**Subject: Geologic Hazards Assessment, Preliminary Soil Design Information,
and Conceptual Drainage Plan Review**
Holub Property, Parcel #3125079010, Redmond, Washington

Conceptual Drainage Plan Review

Surface Water Design Manual Mapped Landslide Hazard Layers

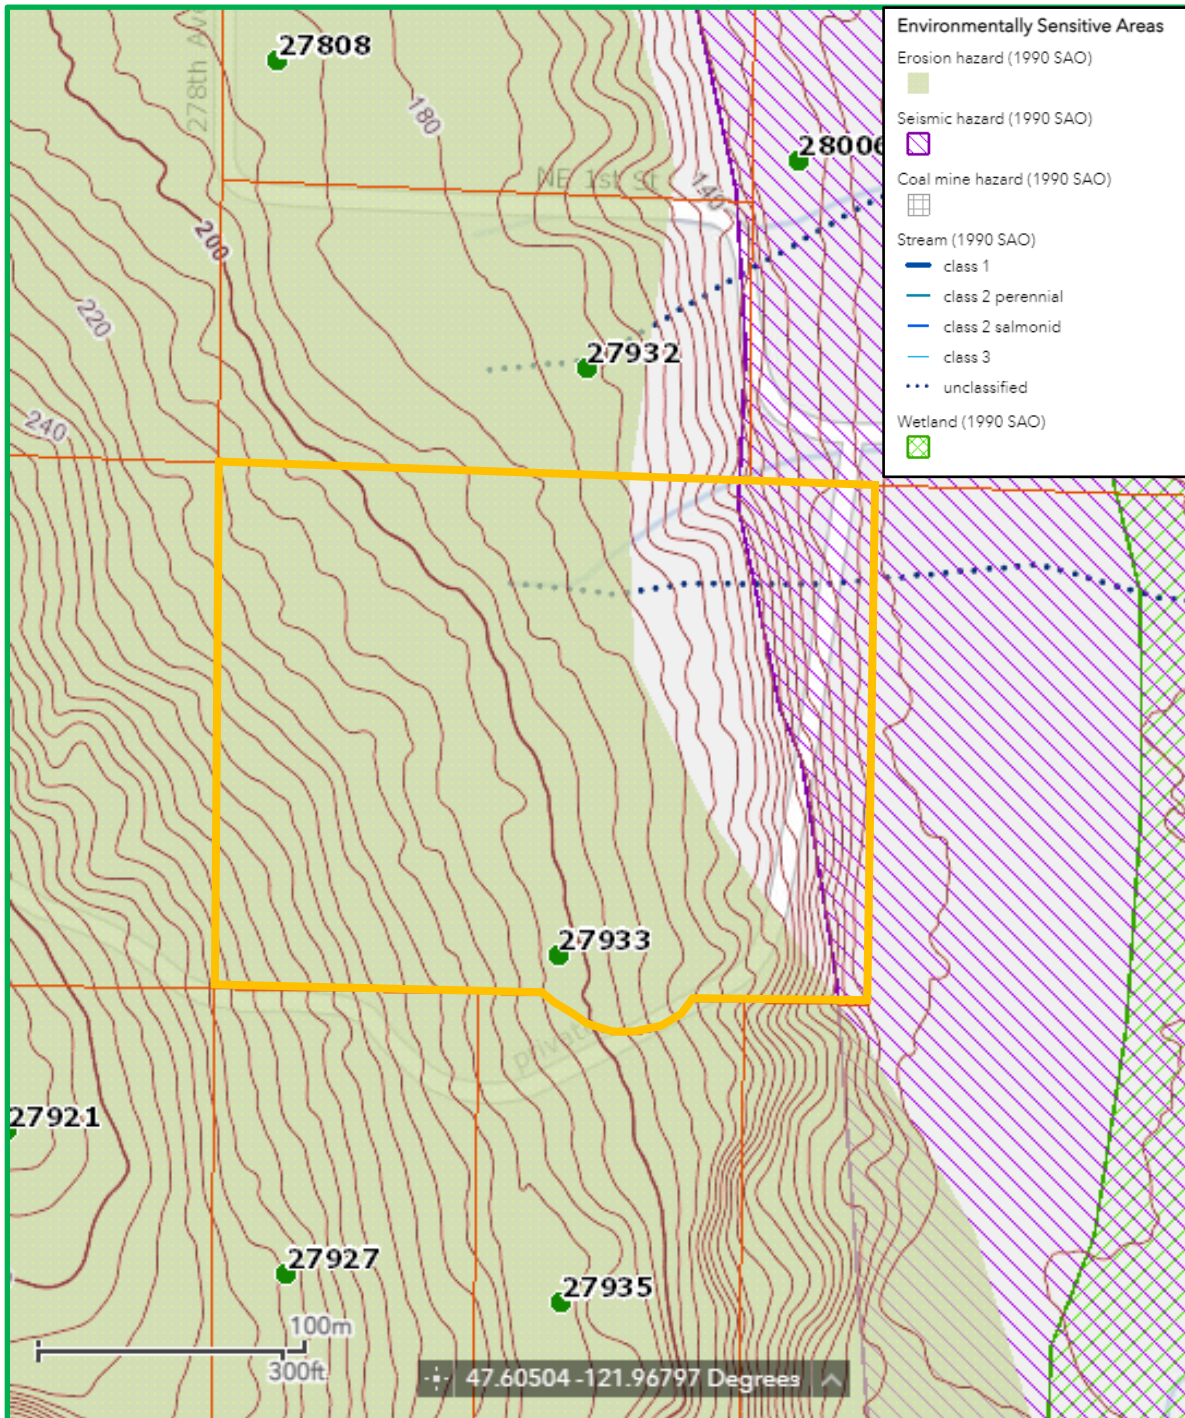
Based upon our site reconnaissance, the topographic and geologic conditions present, and the lack of geomorphic evidence of past landslide activity, it is our opinion that the site conditions do not fulfill the codified definition/criteria of a landslide hazard area (KCC 21A.06.680). However, King County staff brought the Stormwater Services landslide hazard area mapping layer to Mr. Holub's attention. It appears that this mapping layer was designed to flag sensitive drainage basins and natural slopes with respect to stormwater drainage design, but we could not determine from the iMap layer source information what data or interpretation this mapping was based on. We have attached images of the landslide hazard area related iMap layers, the typical layer from the "Environmentally Critical Areas" map tree, which does not indicate the presence of landslide hazard areas, and the "Stormwater Services" map tree mapping layer that shows landslide hazard areas. South Fork Geosciences has reached out to King County staff for clarification with respect to this mapping layer discrepancy, but we have not received a response at the time this letter was prepared.

We presume that the code definition/criteria for a landslide hazard area would dictate the development standards for the property, and the property clearly does not constitute a landslide hazard area per KCC 21A.06.680. Upon clarification of the implications of this "Stormwater Services" mapping layer by King County staff, South Fork Geosciences will provide additional assessment or supplemental information, as required.

Typical Mapped Geologic Hazard Layers

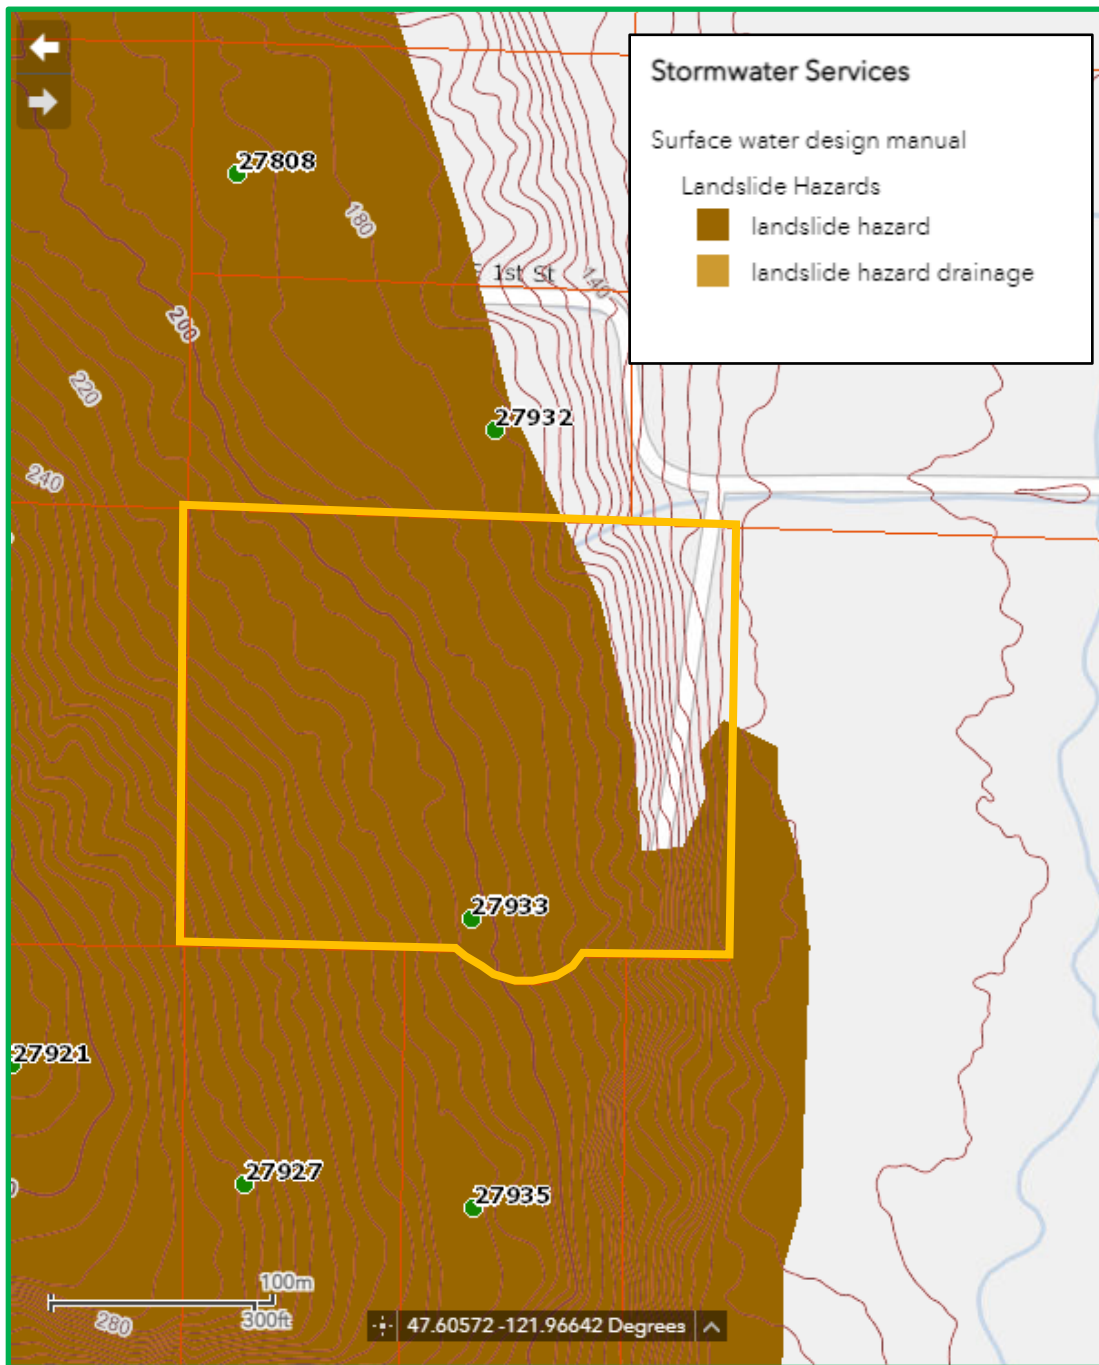
The following discussion of potential geologic hazards is based on the visual reconnaissance of the site, reviews of aerial photographs and regional topographic and geologic maps of the area, and review of the information available on the King County Interactive Mapping Tool (iMap). The iMap information indicates the following geologic hazards: Erosion Hazard Area, Potential Steep Slope Hazard Area, Critical Aquifer Recharge Area (Category 2), Seismic Hazard Area and a Landslide Hazard Area that was within the “Stormwater Services” map layer tree, which is not a typical GIS layer for determining geologic hazards. We will address these items in the following subsections:

A significant portion of the subject property and the area to be developed is mapped as an erosion hazard area. However, erosion hazard areas are not buffered geologic hazards and it is our opinion that erosion and runoff can be controlled during construction by implementing TESC measures consistent with the standard of practice for the Puget Sound region. The following is a partial list of best management practices (BMPs) that should be implemented:

The eastern portion of the property is mapped as a seismic hazard area. This is due to the presence of Quaternary peat deposits in the bog to the east of the property. These soils do not underlie the area to be developed and as such the proposed development should not be encumbered by seismic hazard areas. Liquefaction is a condition where loose, saturated, fine sands lose their shear strength due to rapid pore pressure build-up when subjected to high intensity cyclic loads that can occur during earthquakes. Based on the native, moderately to well-graded sediments underlying the area to be developed and the lack of adverse groundwater conditions (minor perched water rather than a static groundwater table), it is our opinion the liquefaction potential of this site is low, and no mitigations are necessary.
